BMP NUMBER: PC173

DATE: March 9, 2010
TO: Michael J. Gillis, Virginia Correctional Enterprises Document Management Services
FROM: Jo Anna Ripley, Stormwater
PO: 270712
RE: Files Approved for Scanning

Common Area BMP Parcel 1 portion of former
parcel 2

Designed	REC	Drawn	SDC
Scale	1" = 30'	Date	04/05/07
Project No.	6632E10-4		
Drawing No.	2

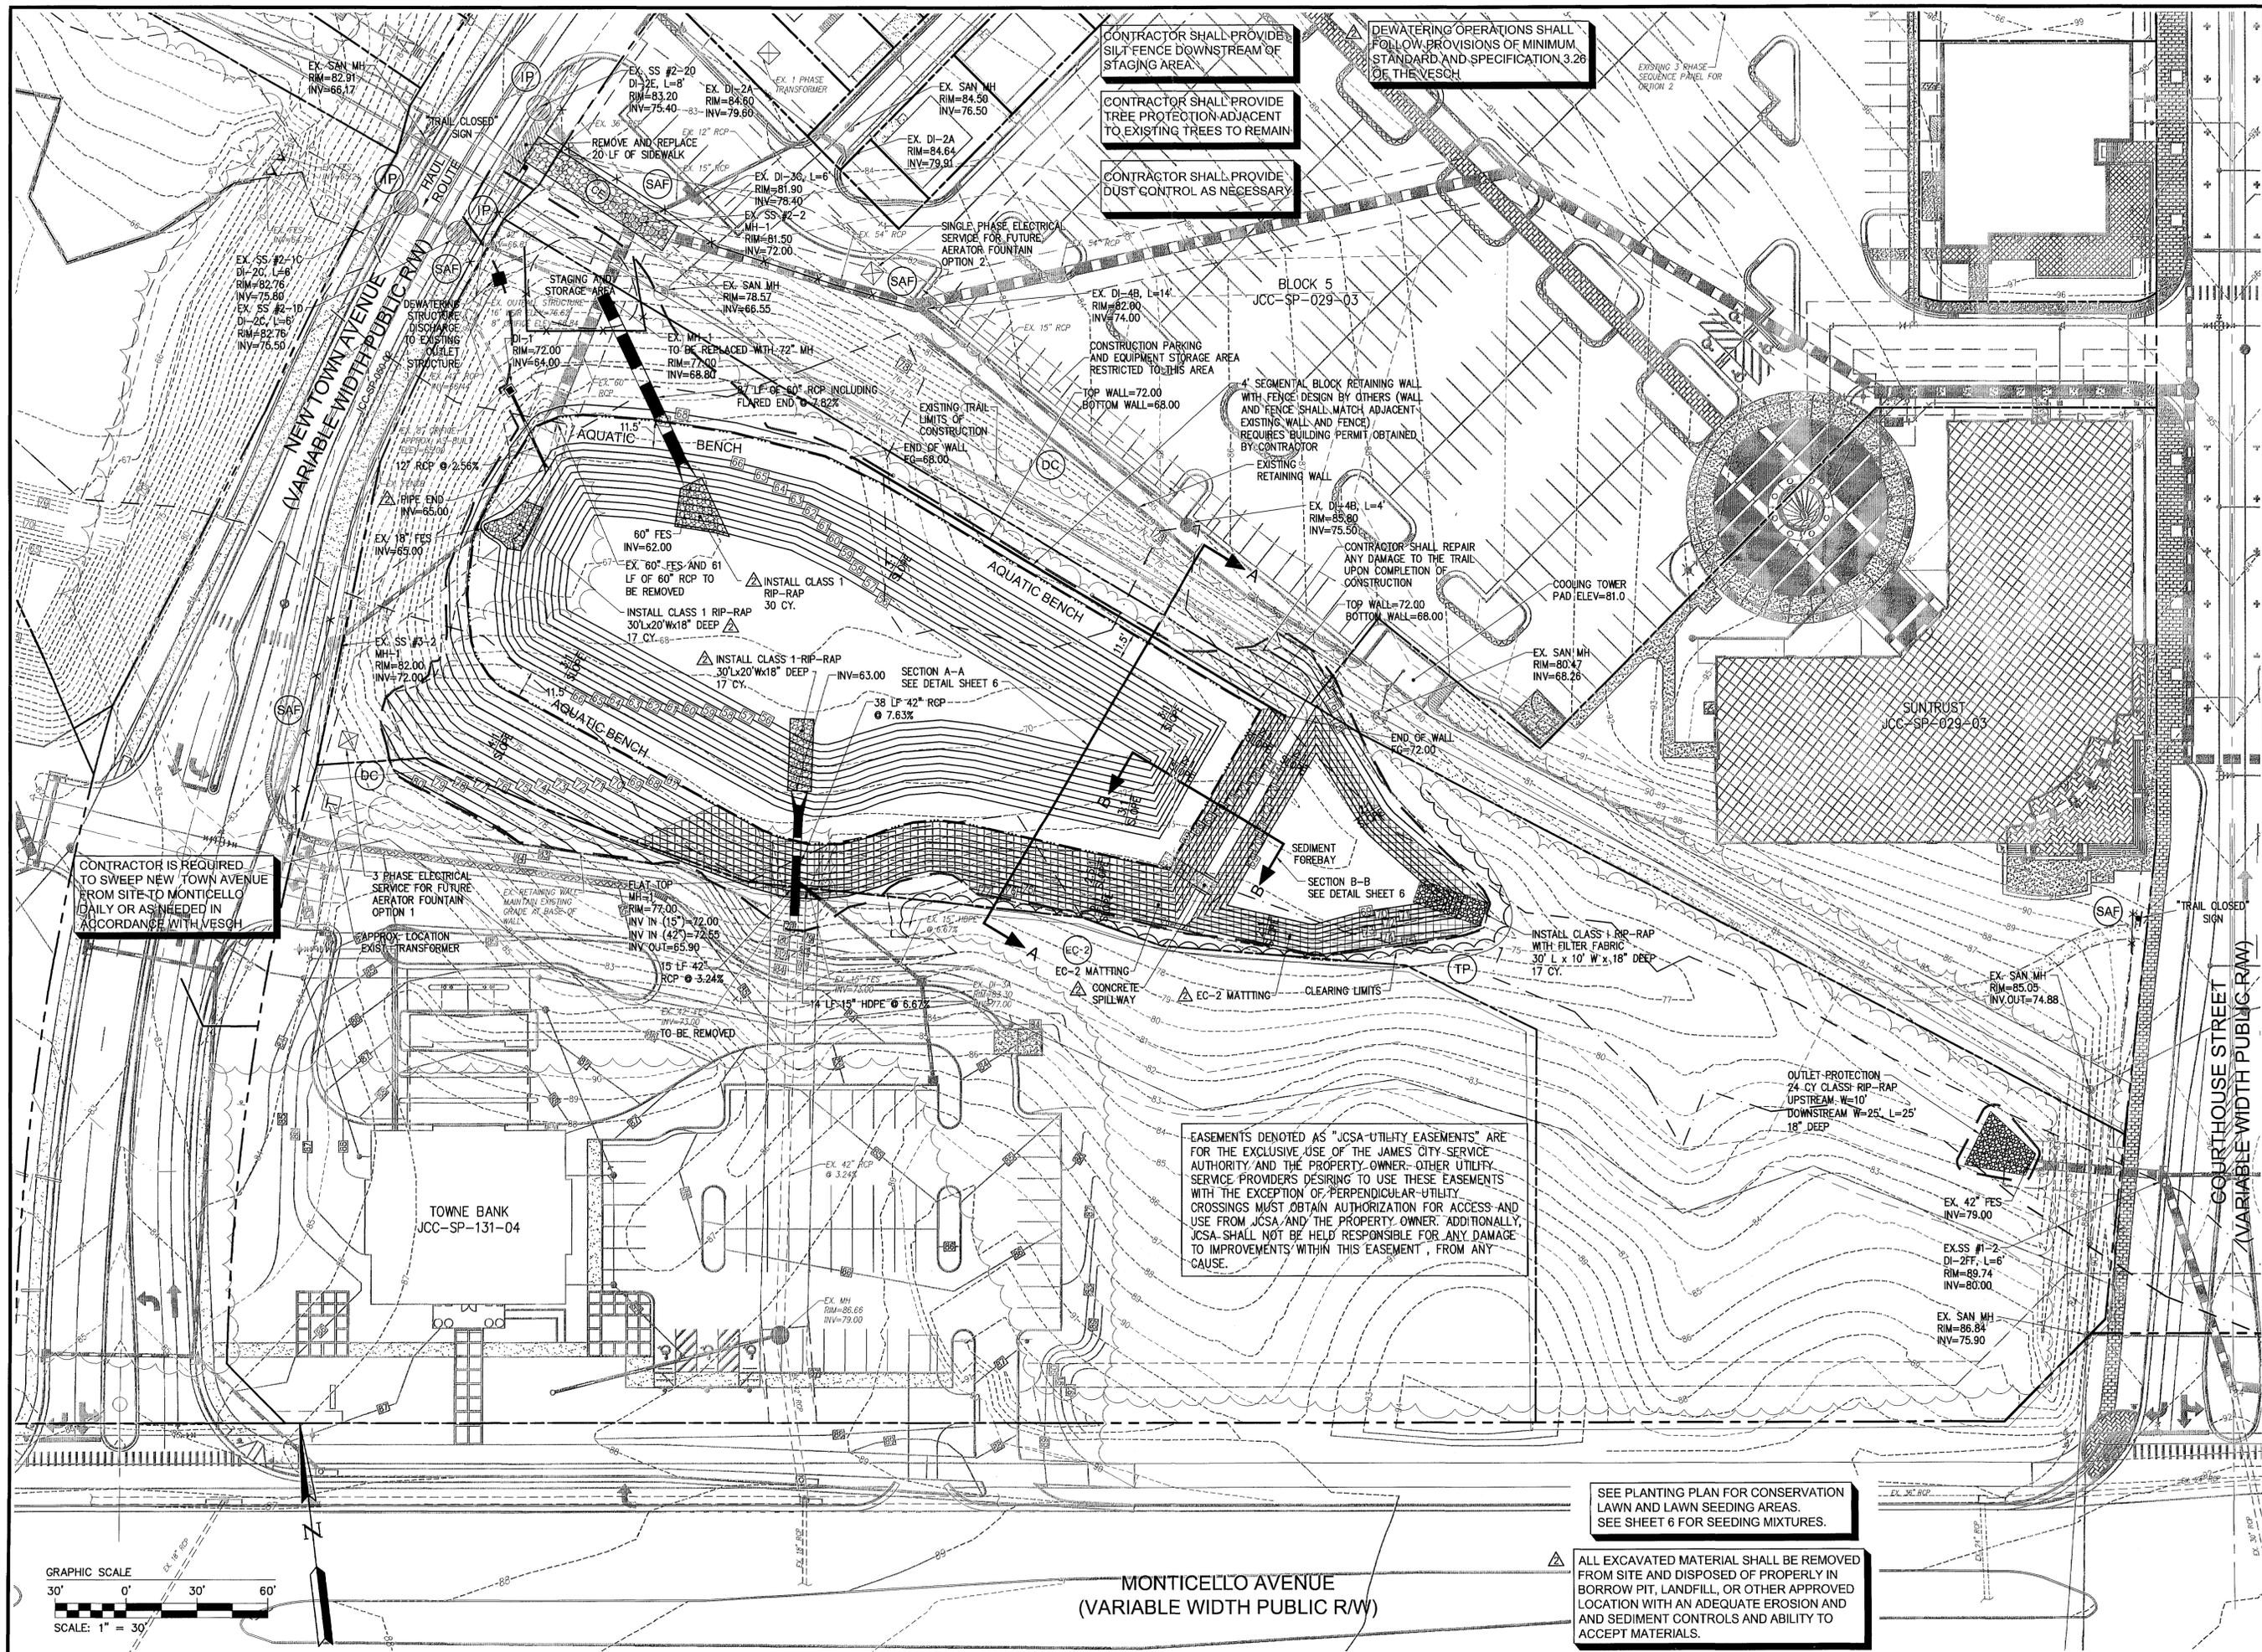
9. Existing Information. All existing storm drainage pipe information needs to be shown on the grading/drainage plan Sheet 3, especially at the four primary inflow pipes into the stormwater basin. Pipe sizes and invert elevations need to be labeled appropriately as well as structure identification numbers from previously approved plans. Also, clearly label information for the existing JCSA sewer which traverses in an east to west direction just to the north of the proposed stormwater basin. No pipe sizes or manhole information was shown on the grading/drainage plan.

- 13d. There appears to be a problem with existing contours on Sheet 3 where grading along the north slope of the stormwater basin meets the parking bay where the construction laydown area is proposed. Either a retaining wall is not labeled or there is a "bust" in elevations between plans.

18. E&S Plan. The following comments pertain to the erosion and sediment control plan as presented for the project on Sheet 3.
 - 18a. The erosion and sediment control plan as presented is more geared toward a final product with pond grading complete and storm drainage pipes upgraded. Disturbance associated with dewatering the existing dry pond and initial clearing and grubbing of the basin area will be very invasive and disruptive to surrounding roads, residences and businesses and the downstream natural environment. Ensure the erosion and sediment control plan adequately addresses this early phase of land-disturbing and site work.

- 18c. The boxed note on the left side of plan Sheet 3 needs to indicate a greater frequency of road sweeping/brushing than weekly. Cleaning in this manner needs to follow the provisions of Minimum Standard # 17 of the Virginia Erosion and Sediment Control regulations.

41. Landscaping. Provide a landscaping plan for the BMP conversion. A boxed note on Sheet 3 shows simple seeding of the aquatic bench with a wetland seed mixture which would not meet the requirements of the County BMP manual and Minimum Standard & Spec. 3.05 of the VSMH.
